**Service Bulletin No:** 53-011  
**Modification No:** EC-09-0594

**FUSELAGE - GENERAL  
INSPECTION FOR GALVANIC CORROSION ON THE UPPER LEFT LONGERON AND REPLACEMENT  
OF THE CHAFING PLATES**

Canopy-lock Chafing Plates - Removal and Installation  
Figure 1

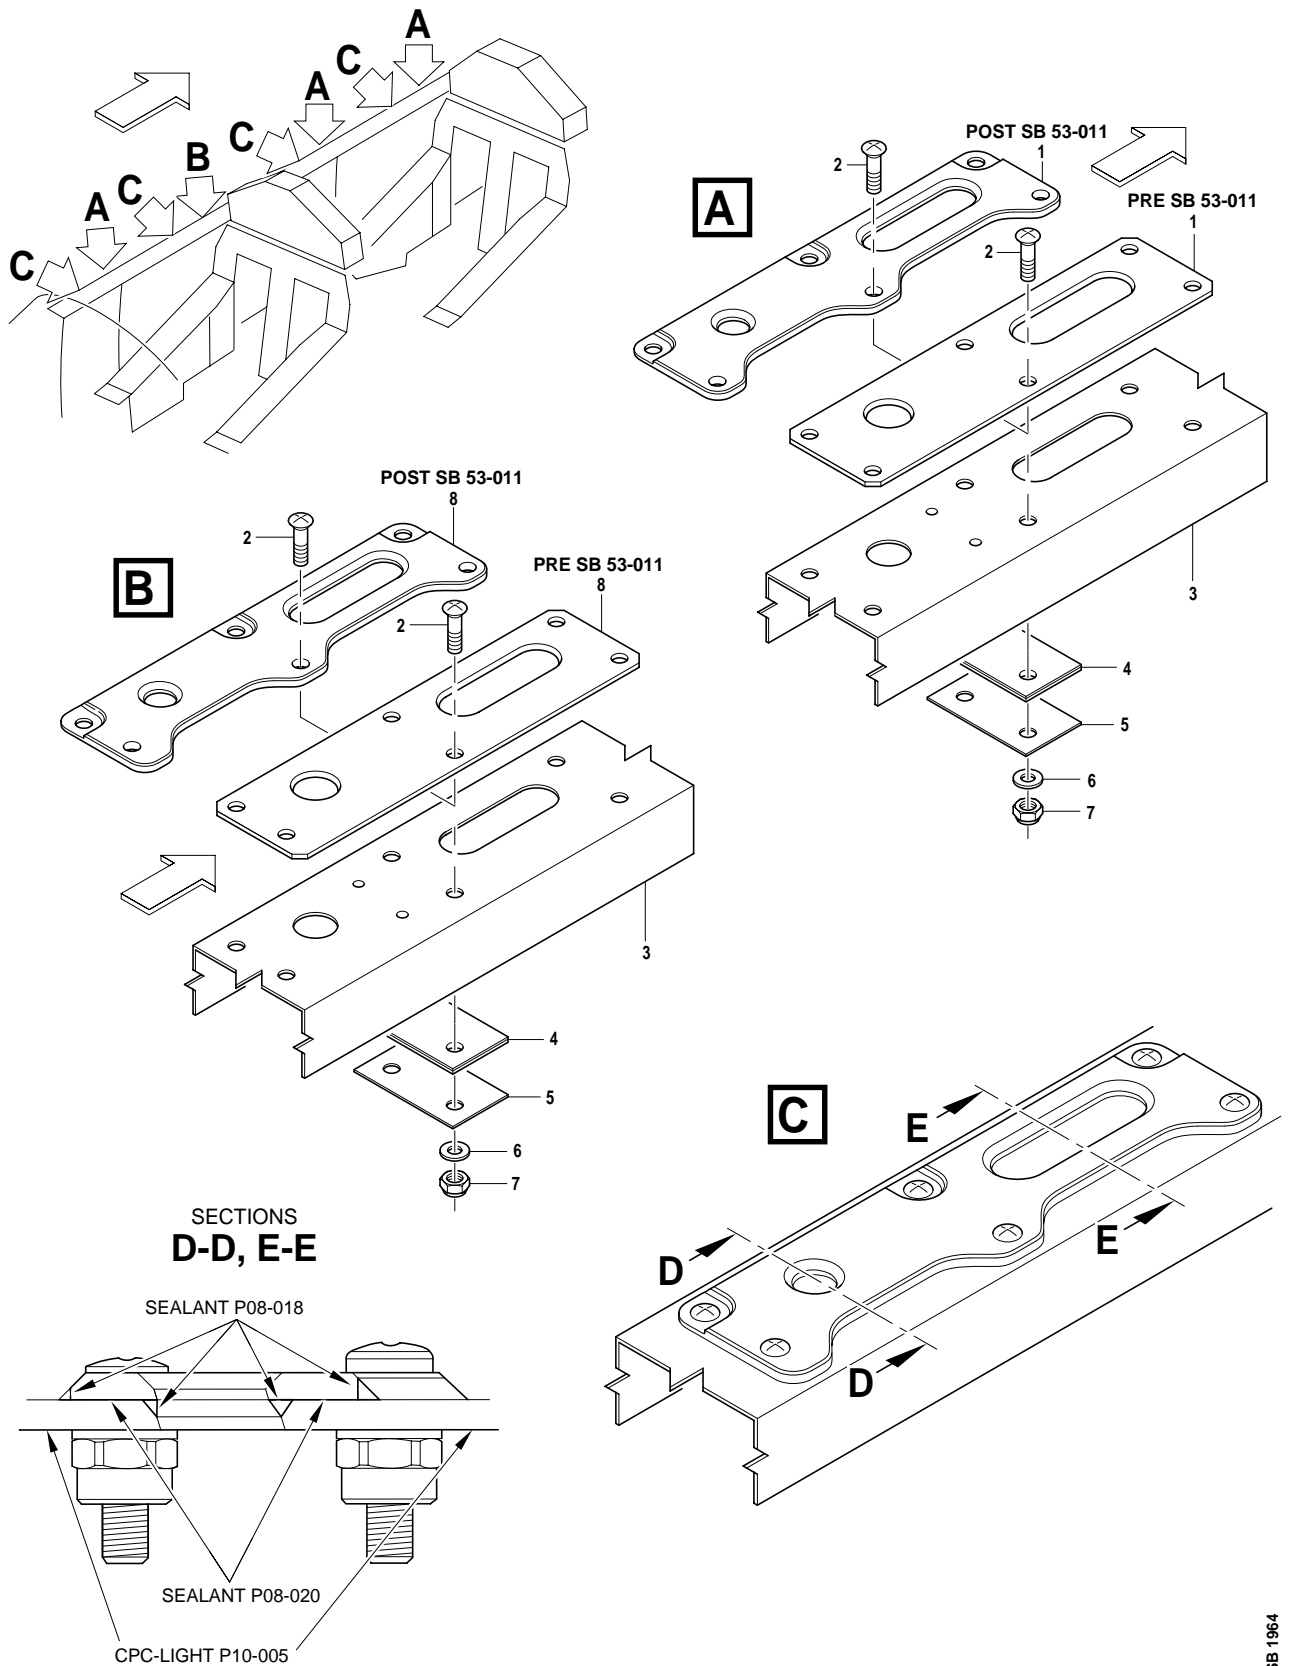
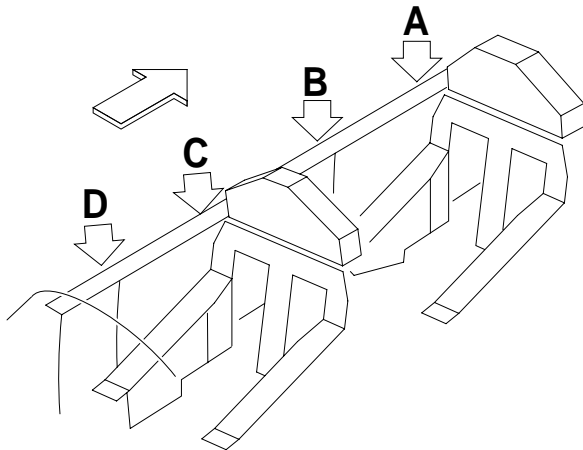
Corrosion has been reported on the upper left longeron underneath the chafing plates for the canopy door latches.

- The use of liquid shim
- Excessive latch chafing that damages and causes removal of the sealant and nucleation of further galvanic corrosion
- Poor application of sealant or finishes such as Alodine to the blended aluminium
- The use of chemical paint stripper.

Do an inspection of the longeron in the specified areas and, if necessary, remove the corrosion. Apply to Pilatus for a repair scheme if the removal of corrosion decreases the metal thickness to less than the specified limits. Install new, more robust, chafing plates.

- (d) Remove and discard the chafing plate (8) and the chafing plates (1).

- (c) Use a X 10 magnifier and look for signs of corrosion in the areas of the chafing plates (1 and 8) on the upper and lower surfaces of the longeron (3) (Ref. SRM, 51-10-01).
- (d) If you find corrosion in Para. 3.B.(2)(c), obey the evaluation and assessment instructions (Ref. SRM, 51-10-02).
- (e) Remove the corrosion (Ref. SRM, 51-10-02) from the longeron (3).
- (f) After you have removed the corrosion in Para. 3.B.(2)(e), measure and record the thickness of the metal in the bare metal areas of the longeron (3). Make an entry in the Aircraft Logbook to record these values.

- (g) If the thickness of the remaining metal is less than:
- 1,8 mm (0.071 in.) at the FWD chafing plate (1) in the front cockpit
  - 2,3 mm (0.091 in.) at the AFT chafing plate (1) in the front cockpit
  - 2,1 mm (0.083 in.) at the FWD chafing plate (8) in the rear cockpit
  - 1,8 mm (0.071 in.) at the AFT chafing plate (1) in the rear cockpit,

- (k) Put the new chafing plates (1) (P/N 553.20.09.326) and (8) (P/N 553.20.09.327) in position on the longeron (3).
  - (l) Put the locking plate assemblies (5) and shim packs (4) in their recorded locations on the longeron (3) (Ref. Para 3.B.(1)).

- (m) Install the new screws (2) (P/N 935.63.11.065), the new washers (6) (P/N 938.77.11.111) and the new nuts (7) (P/N 938.07.68.303).
  - (n) Remove the unwanted sealant (Material No. P08-020).

- The chafing plates (1)
    - The chafing plate (8)
- As shown in Detail C and Section D-D and E-E.
- (q) Apply a layer of the CPC-Light (Material No. P10-005) to the lower surface of the longeron (3) in the areas of the chafing plates (1) and the chafing plate (8).
